CITY OF SEASIDE
BOARD OF ARCHITECTURAL REVIEW

REGULAR MEETING
COUNCIL CHAMBER
440 Harcourt Avenue
Wednesday, April 4, 2018
5:30 PM

- A. BOARD OF ARCHITECTURAL REVIEW APPLICATION NO. BAR -17-15. ARTHUR NOBIDA, PROPERTY OWNER AND APPLICANT, IS REQUESTING DESIGN REVIEW APPROVAL FOR A SECOND STORY ADDITION TO AN EXISTING ONE-STORY SINGLE FAMILY RESIDENCE LOCATED AT 1739 YOSEMITE STREET IN THE SINGLE FAMILY RESIDENCE LOCATED AT 1739 YOSEMITE STREET IN THE SINGLE FAMILY RESIDENTIAL (RS-8) ZONING DISTRICT (APN 012-101-065). THIS PROJECT IS CATEGORICALLY EXEMPT CLASS 1, SECTION 15301.EA, EXISTING FACILITIES, FROM THE CALIFORNIA ENVIRONMENTAL QUALITY ACT. THIS ITEM WAS CONTINUED FROM THE FEBRUARY 21, 2018 BOARD OF ARCHITECTURAL REVIEW MEETING.**

SOUTH ELEVATION
SCALE : 1/4" = 1'-0"

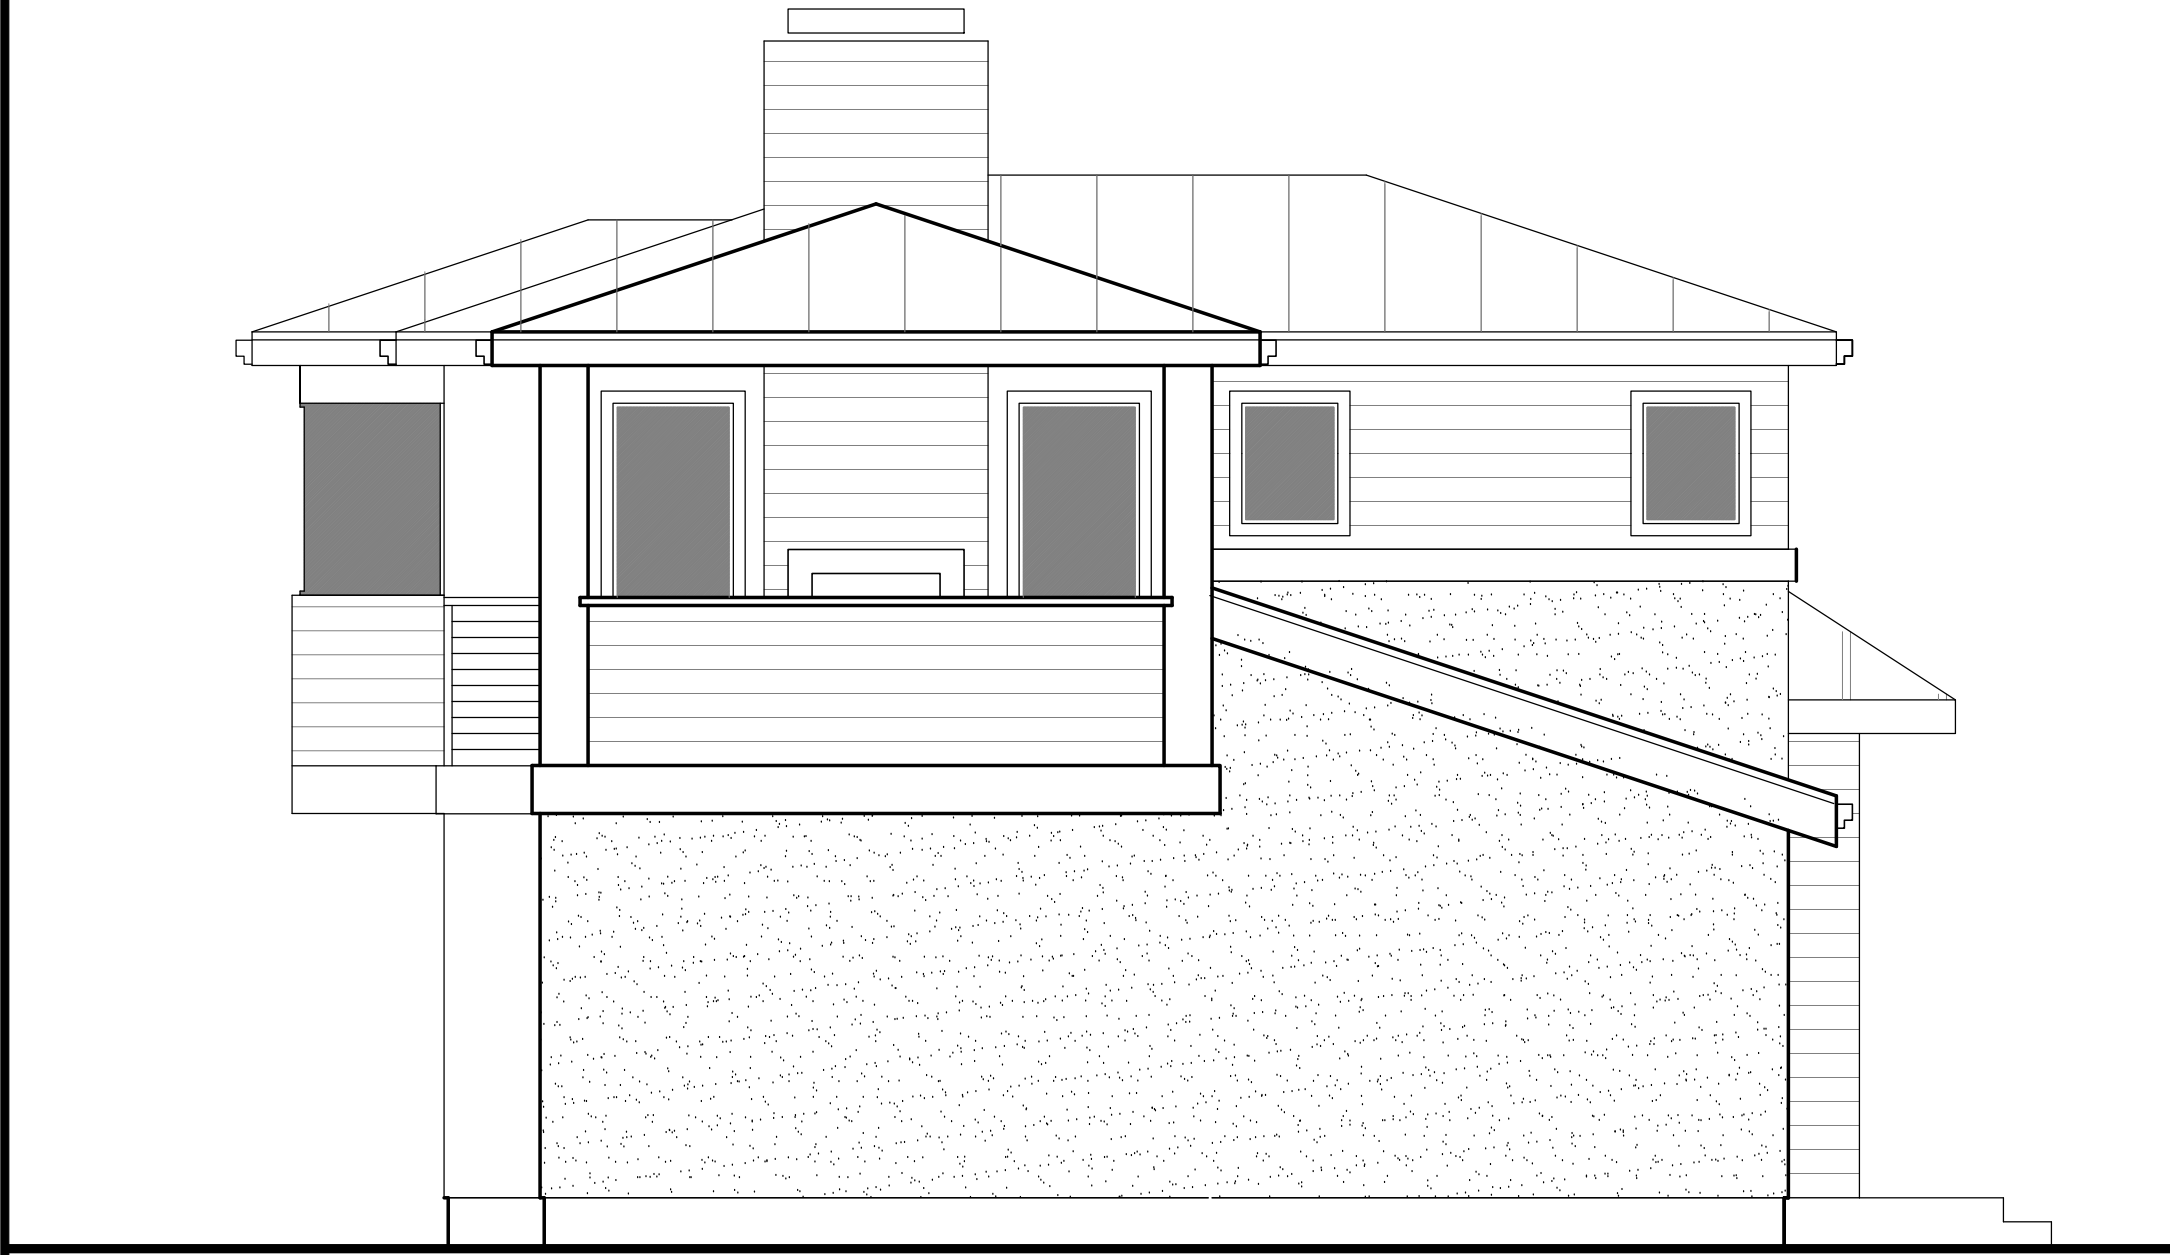
- Consider lowering the 9 foot plate height of the second story.
- Consider modifying the architectural design of the second story element to provide setbacks from the first story.
- Cut back the roof that extends over the second story deck off of the Great Room.
- Review enlarging the front entrance and match this roof to the rest of the house.

The BAR had concerns with the amount roof area being added, substantial second story building offsets from the first floor footprint and the lack of a cohesive entry feature over the front door. The BAR must evaluate the changes to determine if the design modifications made to the proposed project will provide a design which not only meets the minimum design standards but will also provide a cohesive design to blend with the neighborhood.

- 1) Lowered ridge line of roof from 23'5" to 22'6"
- 2) Created flat sections of roof
- 3) Plate height Lowered from 9' to 8'
- 4) Downsized roof width 2' on north and 2' on south side for a total of 4'
- 5) Provided set back of north/east side of 2' over garage
- 6) Shortened height of master bedroom bay window and now frameless
- 7) Front door added hip to match house roof
- 8) Plant 5 Queen Palm trees across backyard property line for neighbors' privacy

- 9) Downsized deck off master bedroom and all wood siding for railing
- 10) Downsized master bedroom and master bathroom shower
- 11) Added window in bathroom facing west
- 12) Added bbq area on south side of deck
- 13) Wood siding for south side of deck
- 14) Changed to vinyl casement windows
- 15) Added wood siding to west side center and larger window at bar

Revised proposal for remodel of KFC/Long John's Silvers

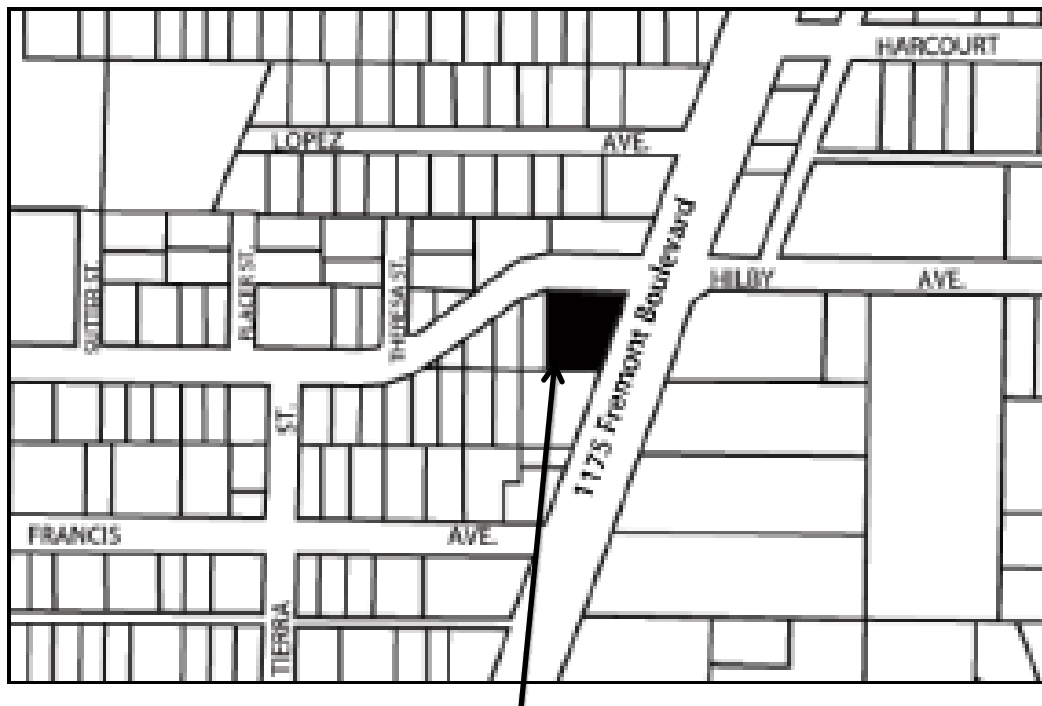
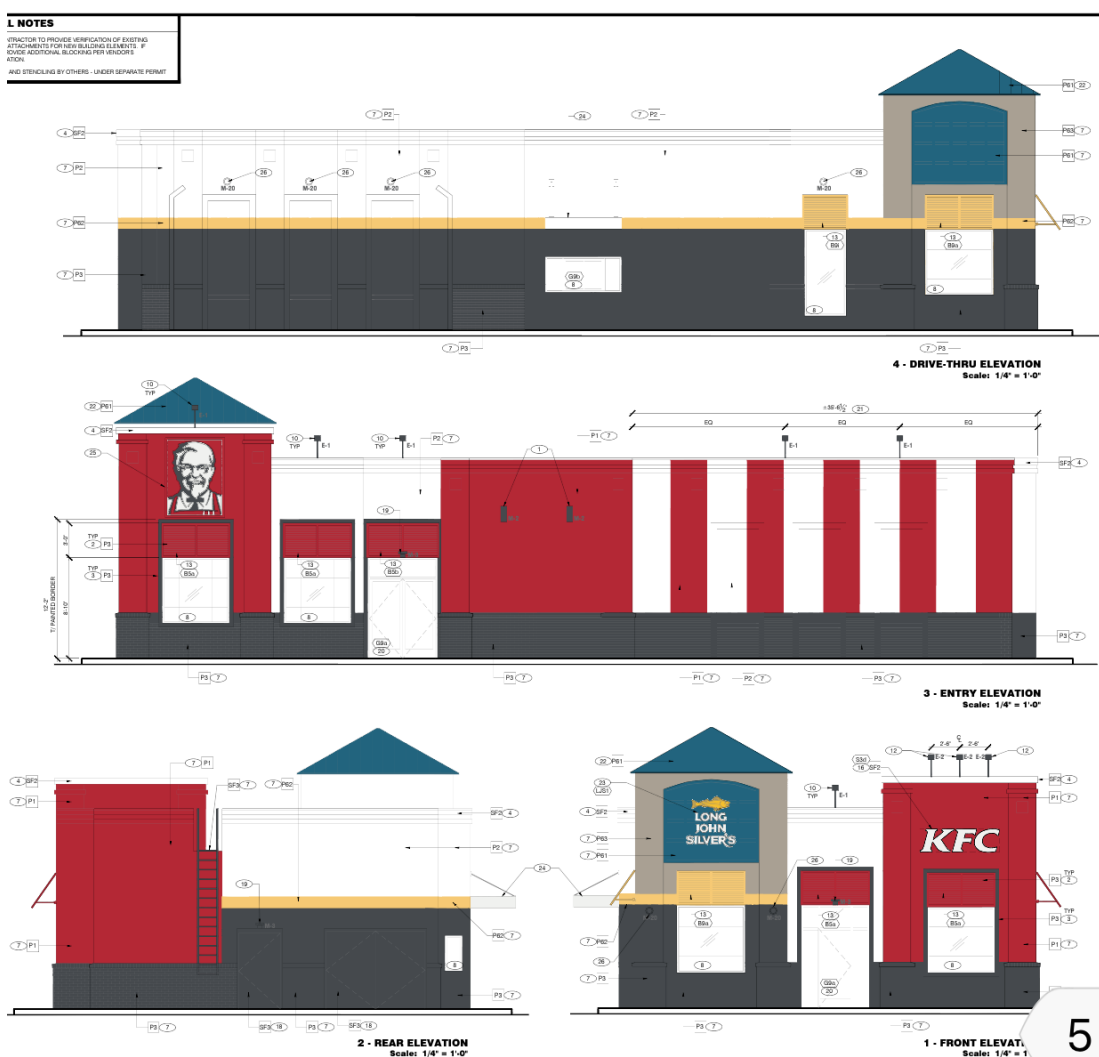
The applicant has submitted plans for a rebranding of the 1,162 square foot building. The plans were corporate directed and display an exterior paint scheme that includes red and white vertical stripes on the rear half of the building, mostly red on the KFC half of the remainder of the building, painting the brick a dark brown, and removing the cupola from the top of the KFC tower. (see Attachment 1, Ex. B – Current KFC Plans) Staff informed the applicant that based on previous BAR actions and current staff expectations, it was not anticipated that the current application would receive favorable BAR approval.

The applicant subsequently submitted revised plans (see Attachment 1, Ex. C – Revised Plans). These plans maintain the original color scheme, lighting, and leave the cupola on the KFC tower. The applicant is proposing that the KFC tower be painted red and the cornice be painted red and white to identify with the KFC brand.

Staff believes that the revised plans keep a unified color scheme on the side and rear elevations while allowing for the branding of each franchise on the front towers with minor modifications to the cornice to in keeping with the franchise branding.
